**Sur-Rebuttal Analysis  
of the Applicant's  
Experts' Rebuttal Opinions**

By  
Dr. Willem A. Schreüder & Dr. Devraj Sharma  
Principia Mathematica Inc.

June 19, 2000

Case No. 96CW014: Application for Water Rights by Park County Sportsmen’s Ranch, LLP

Figure SR-5a.

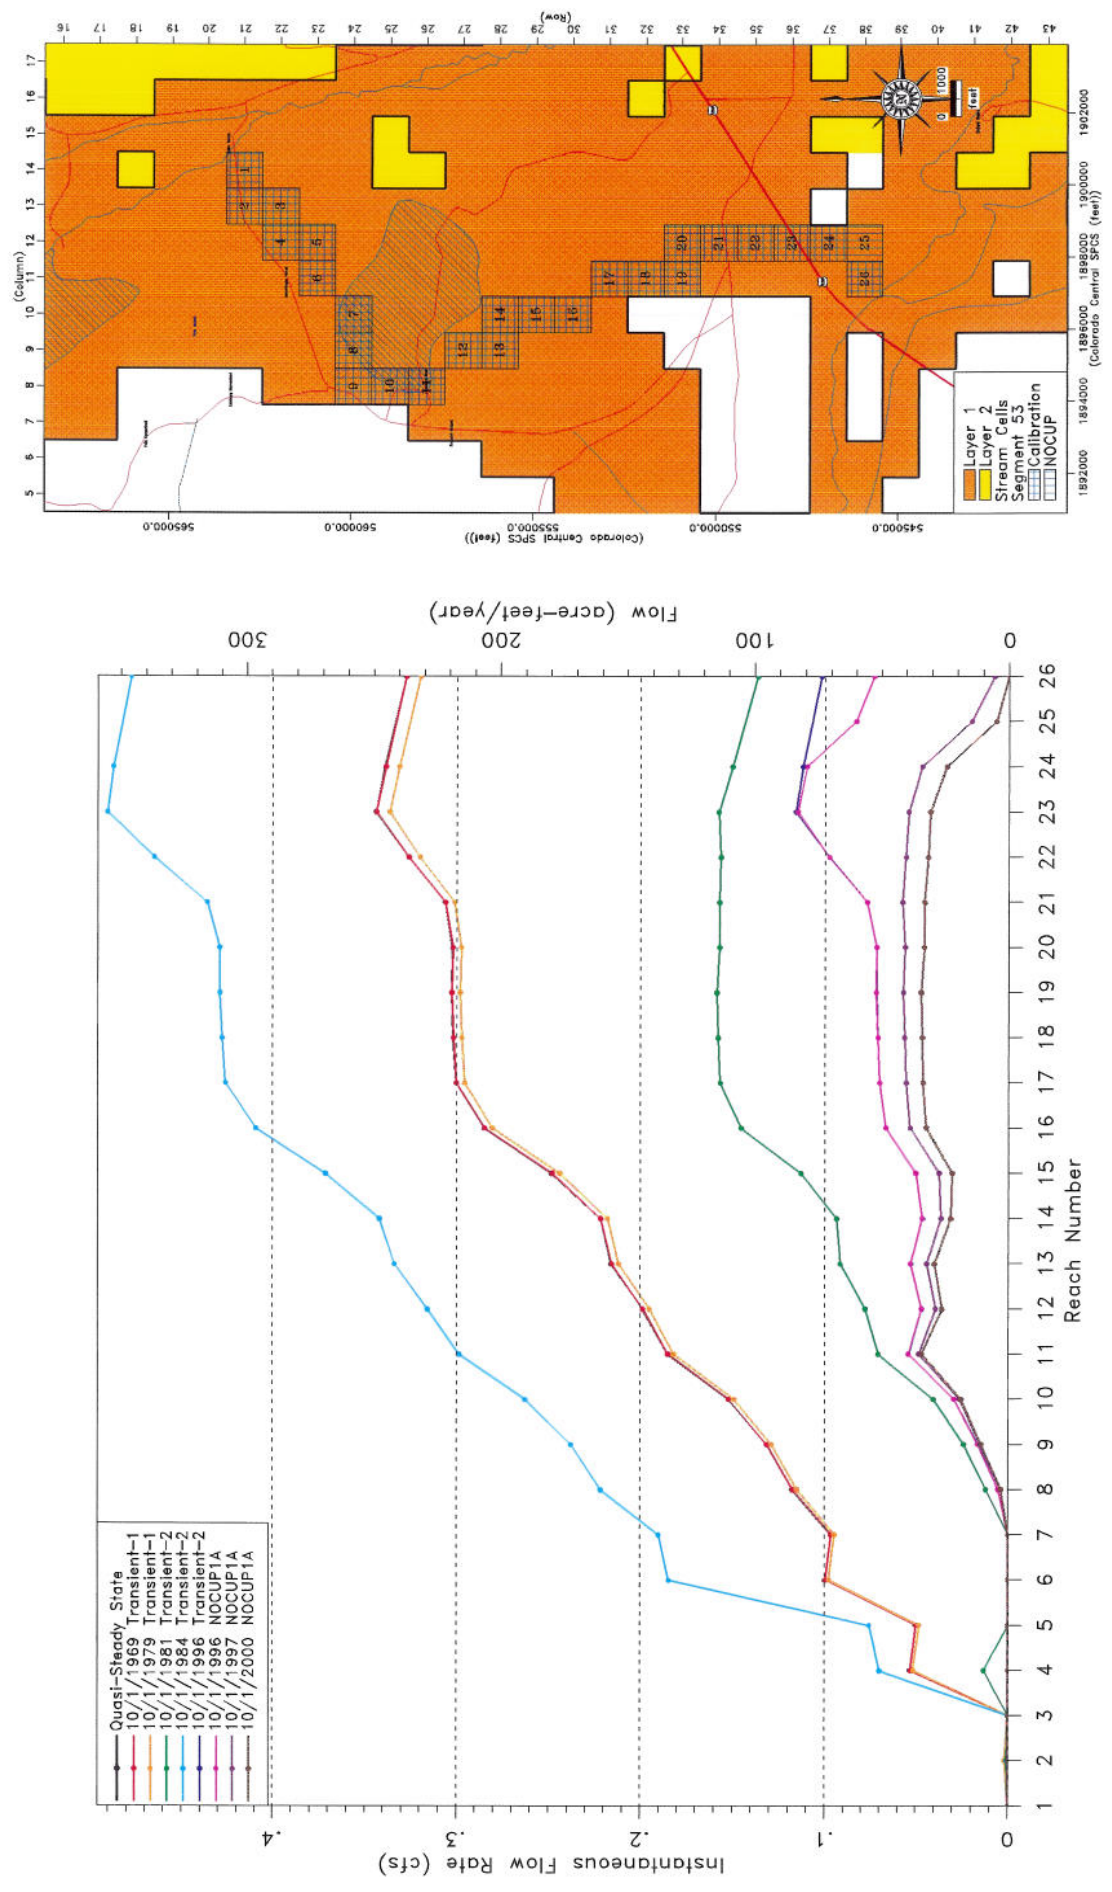
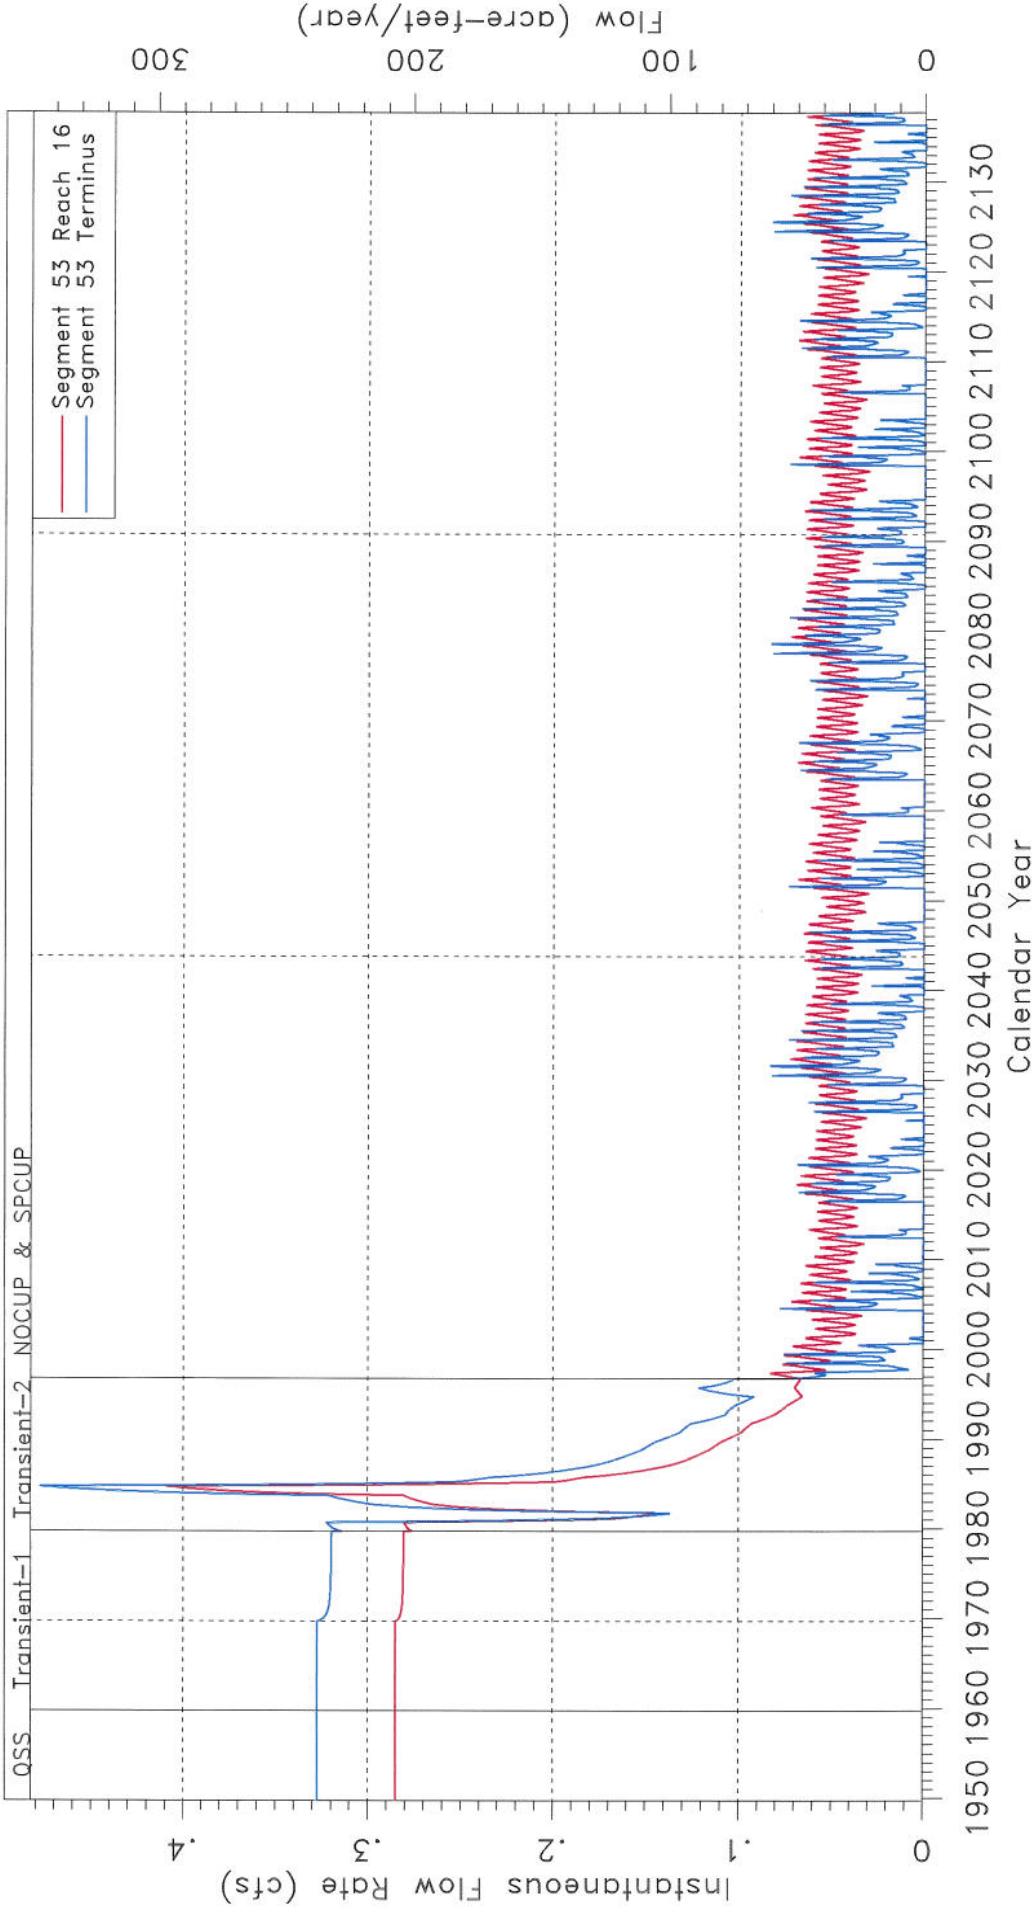
- (29) Applicant's experts opine in rebuttal that errors in the representation of historical conditions are of no consequence. Therefore, the unreliability of the Applicant's model calibrations to historical conditions in South Park has been further analyzed by Principia. These historical conditions represented in the NOCUP model runs in fact includes the proposed North Branch Collection System (NBCS) ditch, that is proposed to be constructed in the future. The findings from this analysis are presented in Figures SR-5a and SR-5b. The predicted instantaneous flow rate in the reaches of the NBCS lying between Michigan and Tarryall Creeks, under the various conditions simulated by the Applicant is depicted in Figure SR-5a along with a cameo map indicating the model representation of the NBCS. Several facts become clear in this figure: that the NBCS not only appears in the NOCUP representation of reality prior to its proposed construction, but it also appears in the quasi-steady state (QSS) and transient model calibration conditions; that the predictions for the same reach change even in the historical conditions represented as the QSS, transient and NOCUP; and, that the NBCS acts as a drain carrying captured groundwater during the QSS, transient and NOCUP model simulations made by the Applicant when no such flow should exist. The significance of these entirely unreliable predictions is clarified further in Figure SR-5b which depicts the predicted flow rates in the NBCS, Segment 53, at two reaches; the first shown in red represents Reach-16 which lies approximately midway in the NBCS as represented; and, the second shown in blue represents the terminus reach. The model clearly predicts flows in this non-existent ditch of approximately 35 acre-feet per year under NOCUP conditions and in excess of 200 acre-feet per year under QSS conditions. It thereby conveys ground water from the Michigan Creek ground water sub-basin to the Tarryall Creek sub-basin, when in fact natural ground water flows preclude any such conveyance. The Applicant's model has in fact been 'calibrated' to such unrealistic ground water conveyances.

Figure SR-6

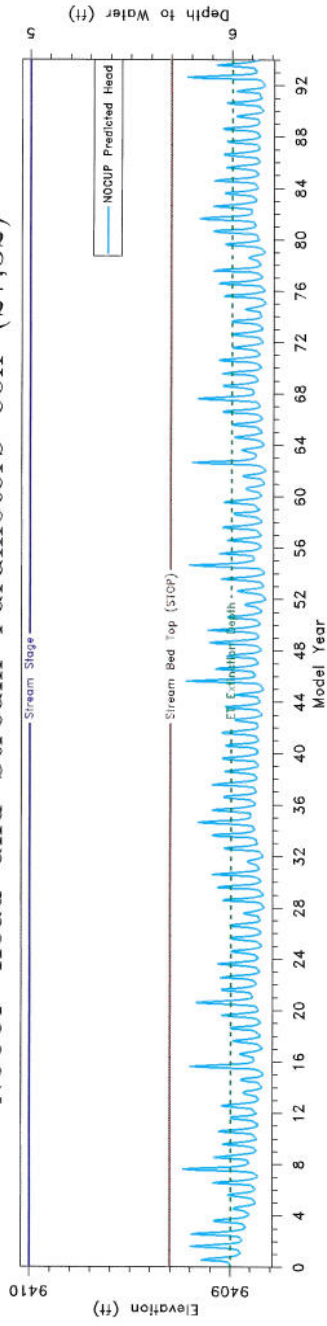
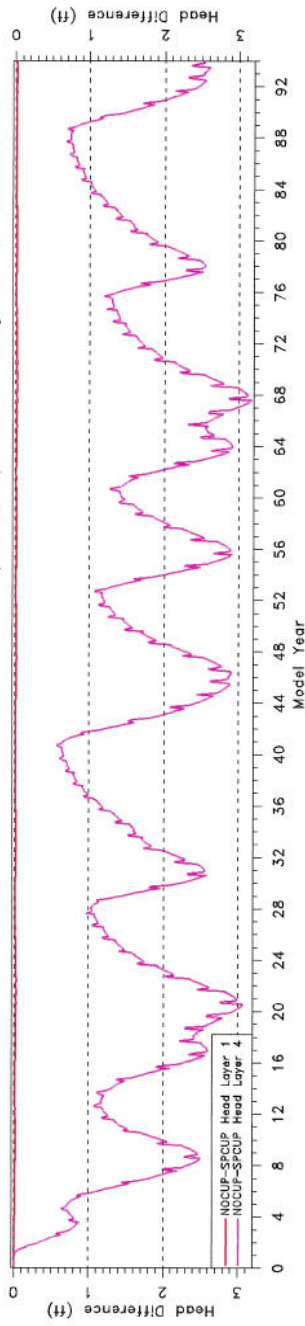
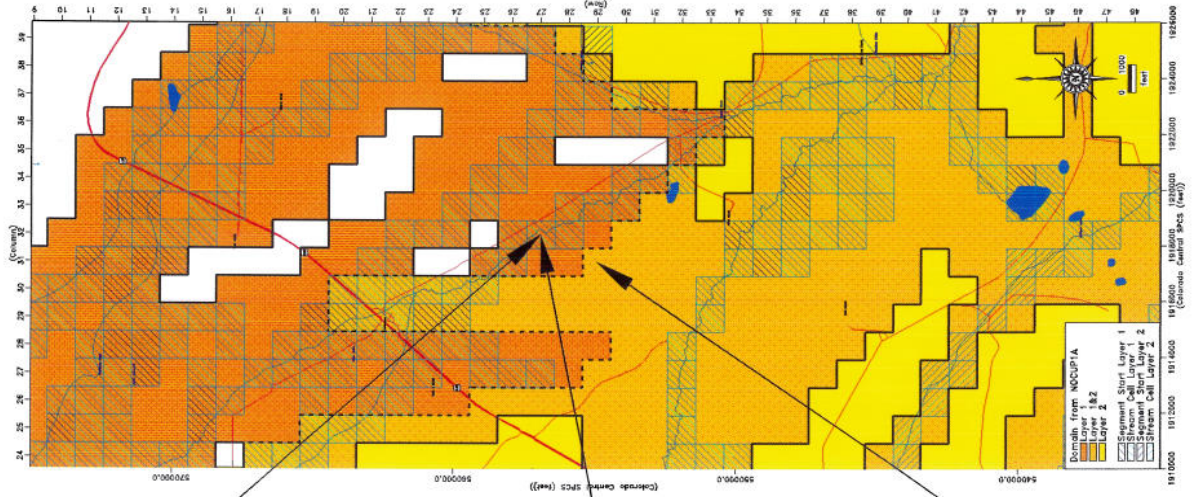
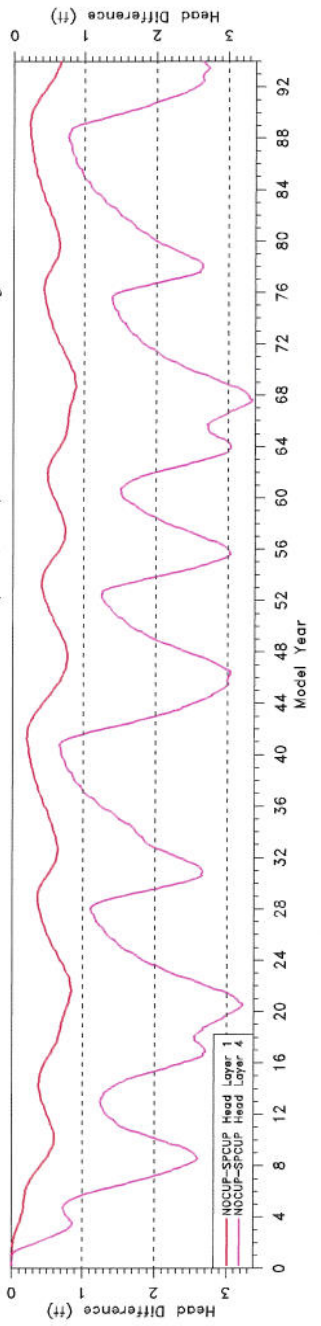
- (30) In rebuttal, Applicant's experts opine that model layering choices do not adversely effect the reliability of the model. The unreliability of the Applicant's model in predicting stream

leakage and thus impacts to streams caused by the Applicant's project has therefore been further evaluated by Principia in this context. The findings are illustrated in Figure SR-6 which consists of three hydrograph frames and an associated cameo map of the affected model grid cells. The top hydrograph frame depicts the prescribed stream parameters in a grid cell (27,32) used to represent a portion of Jefferson Creek and the ground water head in layer 1 predicted by the model under NOCUP conditions. The second or middle hydrograph frame depicts the difference between the NOCUP and SPCUP ground water heads predicted by the model at that grid cell, for model layers 1 and 4. It should be noted that the Applicant had chosen to represent layers 2 and 3 as absent below layer 1 in this grid cell, eliminating the possibility of flow between layers 1 and 4 in the model at this location. The bottom hydrograph frame depicts similar information in a nearby grid cell (29,31). From the middle frame, one could infer that the model predicts little or no impact, assessed simply by the subtraction of the NOCUP predicted head from the SPCUP predicted head, both of which are flawed of course. However, the same frame also allows the inference to be made that had the Applicant not deliberately removed model layers 2 and 3 from the grid cell location, the calculated impacts would have been much greater. As shown in the first frame, the difference between the aquifer head and stream stage is about one foot in the NOCUP simulation. A difference of one foot between the NOCUP and SPCUP simulation would therefore double the predicted stream leakage from Jefferson Creek at this location. Clearly, even differences of a fraction of a foot between the NOCUP and SPCUP simulations would significantly alter the predicted leakage from Jefferson Creek at this location. This inference is further substantiated in the bottom frame which demonstrates that an impact in layer 1 of almost a foot is predicted when model layers 2 and 3 are in fact present between layer 1 and layer 4. Therefore, the choices of hydrogeologic representation implemented by the Applicant have thus pre-determined just what the impacts predicted by the model would be to Jefferson Creek.

Figure SR-7.

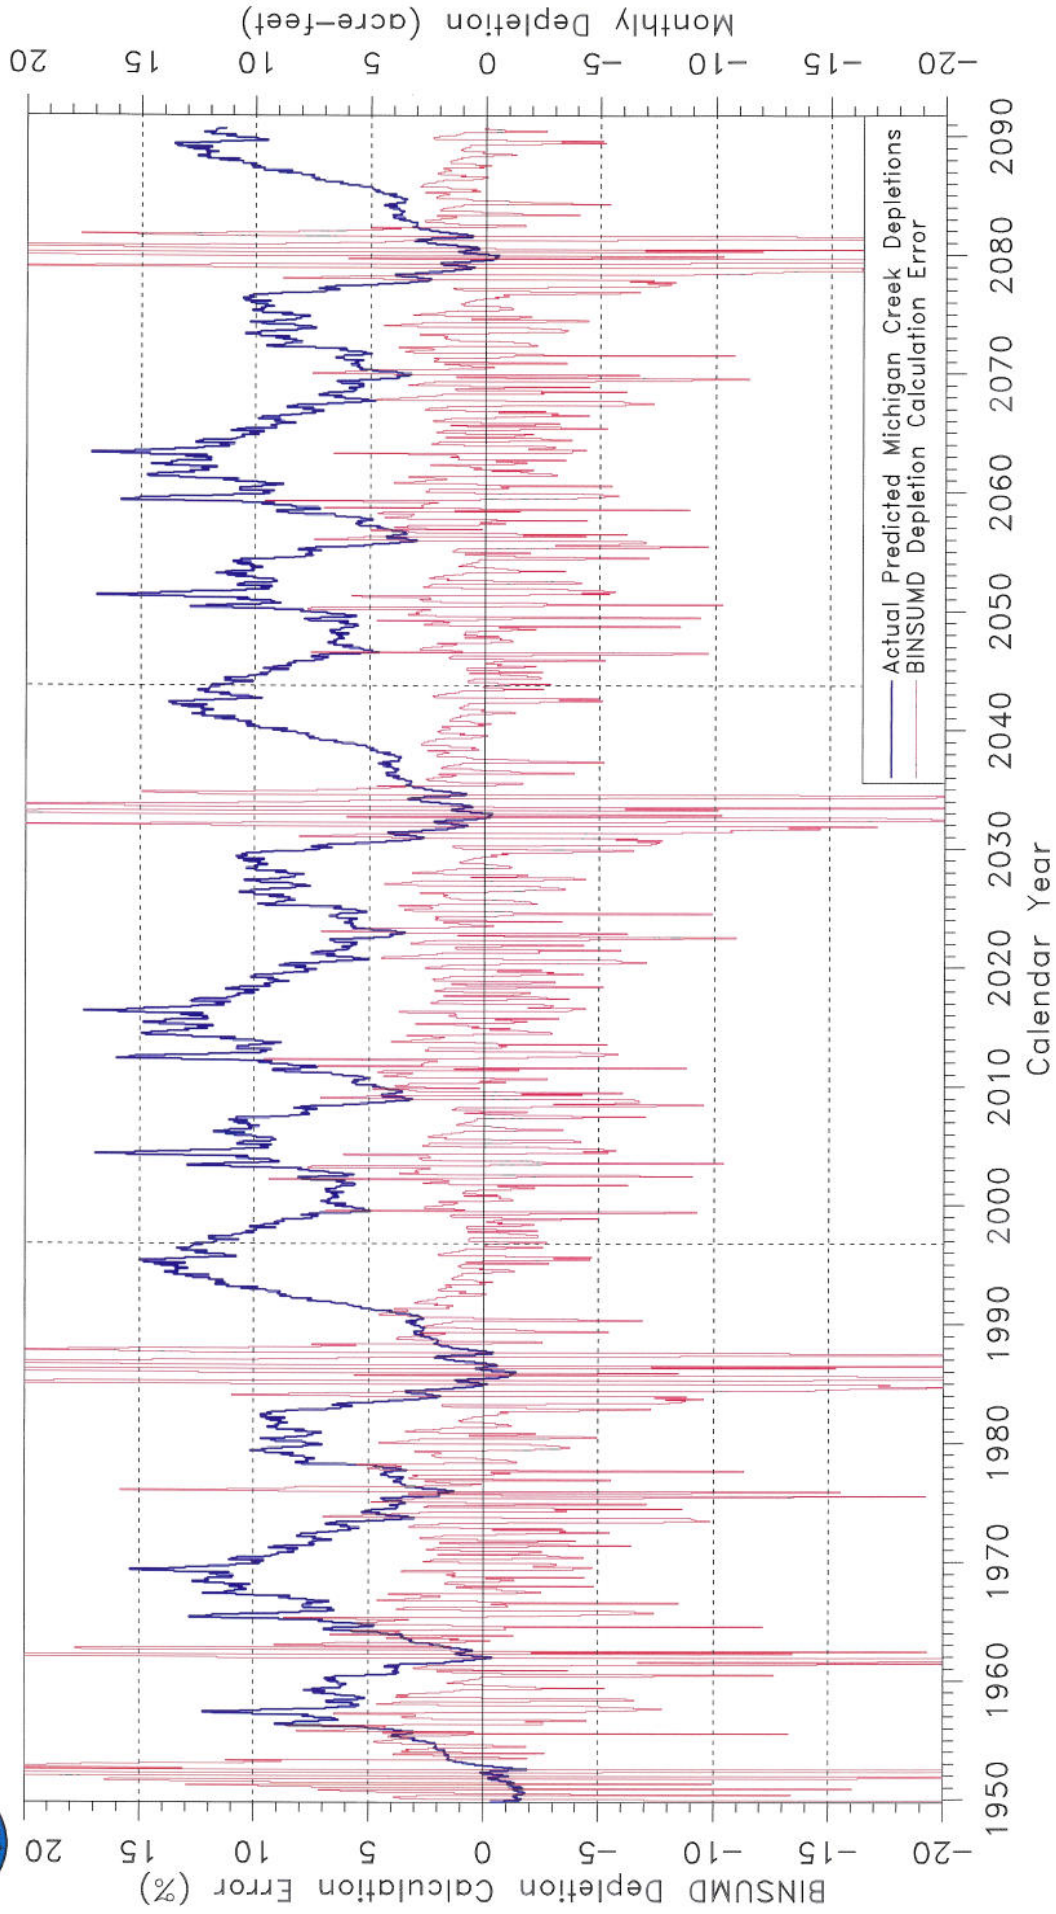
- (31) Notwithstanding the rebuttal opinion offered by the Applicant's modelling expert, Principia's sur-rebuttal analysis indicates that the calculational errors in the procedure employed by the Applicant to estimate depletions to Michigan Creek are, in fact, significant. The findings from this analysis are presented in Figure SR-7. The blue line in this figure denotes the monthly value of stream depletions, defined as the subtraction of the NOCUP stream-aquifer interactions from the corresponding SPCUP values, each of which was previously demonstrated to be flawed, actually predicted by the Applicant's model. The red line in the same figure represents the percentage error in the calculation procedure used which was previously demonstrated to rely upon end-of-month values rather than the instantaneous values actually calculated by the model. These errors have been depicted in a range between +20% and -20%, i.e. within a band of 40%, which is significant. The same type of calculational error effects not only stream depletions, but also other quantities such as evapotranspiration, which are calculated in a similar manner. The error is further propagated

by the surface water model that uses these incorrectly calculated values. The calculational errors are therefore significant.
